Access Compliance Report

Public Rights-of-Way

Intersection ID: 29473	Main Street: HAWTHORNE_BRIDGE_CT	Cross Street: HAWTHORNE_LN	Location: SW
ADA ID: A5C9FB498479	Ramp Type: Perp	Initial Pass/Fail: Fail	Overall Compliance: No
Severity Score: 37.5			
Codes/Mitigation Info/Possible Solution		Field Measurements/Component Compliance

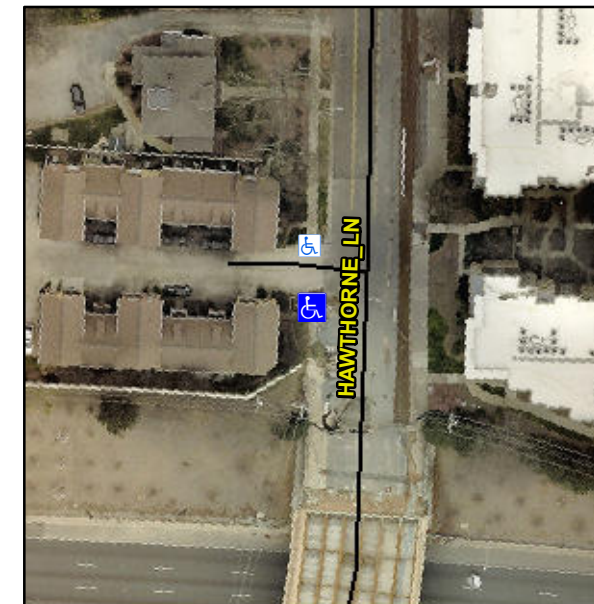
R304.2.2, R304.5.3

Compliance	Description	Data	Compliance	Description	Data
N/A	Ramp Length (in)	47.0	No	Ramp Slope (%)	10.1
Yes	Ramp Width (in)	73.0	No	Ramp XSlope (%)	8.4
N/A	Flare Type LT	N/A	N/A	Flare Type RT	N/A
N/A	Flare Slope LT (%)	N/A	N/A	Flare Slope RT (%)	N/A
N/A	Flare Traversable LT?	N/A	N/A	Flare Traversable RT?	N/A
N/A	Landing Length (in)	N/A	N/A	DWS Provided?	N/A
N/A	Landing Width (in)	N/A	N/A	DWS Contrast?	N/A
N/A	Landing Slope (%)	N/A	N/A	DWS Length (in)	N/A
N/A	Landing X Slope (%)	N/A	N/A	DWS Full Width?	N/A
N/A	Landing Curb? (Y/N)	N/A	N/A	DWS Offset (in)	N/A
N/A	Shared Landing?	N/A			
N/A	Gutter Ponding?	N/A	N/A	Gutter Slope (%)	N/A
N/A	Gutter Lip Ht (in)	N/A	N/A	Gutter X Slope (%)	N/A
N/A	Painted X Walk1?	No	N/A	Painted X Walk2?	N/A
	X Walk 1 Direction	To N		X Walk 2 Direction	N/A
N/A	X Walk 1 Width (in)	N/A	N/A	X Walk 2 Width (in)	N/A
	X Walk 1 Slope (%)	0.4		X Walk 2 Slope (%)	N/A
	X Walk 1 X Slope (%)	6.4		X Walk 2 X Slope (%)	N/A

Remove & Replace Entire Ramp.
